## Product Change Notification

<b>PN Number:</b>	PN26-032	<b>Date:</b>	15.05.2026
<b>Revision:</b>	0	<b>Author:</b>	Rastislav Kosiba

<b>Product class:</b>	SEMIPACK
<b>Subject of change:</b>	Change of housing sealing and module packaging for SEMIPACK 1 6th generation modules

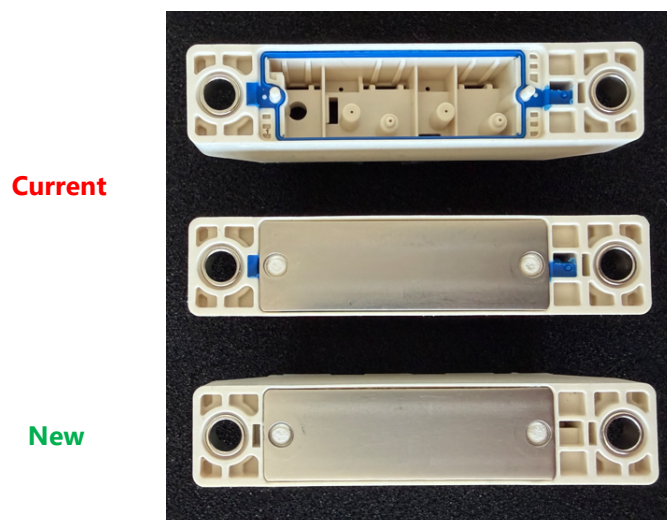
- Description:**
- 1) Replacement of the sealing between the housing and the baseplate of legacy SEMIPACK 1 6<sup>th</sup> generation modules, substituting the blue seal with an industry standard adhesive.

2) The packaging of SEMIPACK 1 6<sup>th</sup> generation modules will also be updated. The new packaging will be identical to that used for SEMIPACK 1 5<sup>th</sup> generation modules.
